# Work Order ID 76661

Item ID: D412-664-203TRN Accept **\*N900040100\*** Setup Start **\*NS1\***  
 Revision ID: Stop **\*NS2\***  
 Item Name: Crosstube Turning Detail  
 Start Date: 18/11/2011 Start Qty: 1.00 **\*1\*** Cust Item ID:  
 Required Date: 02/12/2011 Req'd Qty: 1.00 **\*1\*** Customer:  
 Reference:

DRAWING NO. D412-664-243	TITLE CROSSTUBE ASSEMBLY (412 HI AFT)	REV. E	DART AEROSPACE LTD ENGINEERING ORDER		D.E.O. NO. D412-664-243-E-1	SHEET NO. SHEET 1 OF 2	SCALE NTS
DRAWN	CHECKED	MFG. APPR.	APPROVED		DE APPR.		
DATE 11.03.31	DATE 11/03/31	DATE 11.03.31	DATE 11/03/31		DATE 11.03.31

DRAWING NO. D412-664-243	TITLE CROSSTUBE ASS'Y (412 HI AFT)	REV. E	DART AEROSPACE LTD ENGINEERING ORDER		D.E.O. NO. D412-664-243-E-2	SHEET NO. SHEET 1 OF 1	SCALE NTS
DRAWN 92	CHECKED ASS	MFG. APPR. RE	APPROVED MP		DE APPR. MP		
DATE 11.09.07	DATE 11.09.19	DATE 11.09.19	DATE 11.09.19		DATE 11.09.19

**D212-664-243**  
**ASSEMBLY DETAIL**

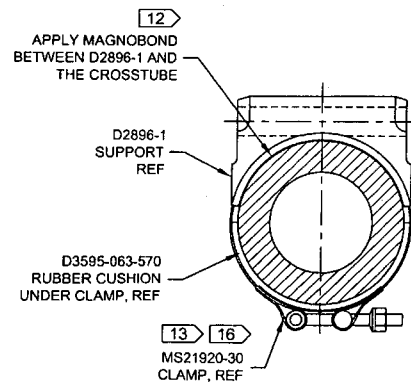
REMOVED ABRASION STRIP IN FAVOR OF A THIN LAYER OF PROSEAL 890.

D2856-600-1009 ABRASION STRIP  
D3189-1 CHAFING SHIELD (1, INSTALLED OVER ABRASION STRIP)  
MS21920-28 CLAMP, 2X  
2 PL

D3189-1 CHAFING SHIELD (1, INSTALLED OVER PROSEAL 890)  
MS21920-28 CLAMP, 2X  
2 PL

MASK AREA PRIOR TO PAINTING AND  
APPLY CLEAR COAT AFTER PAINTING
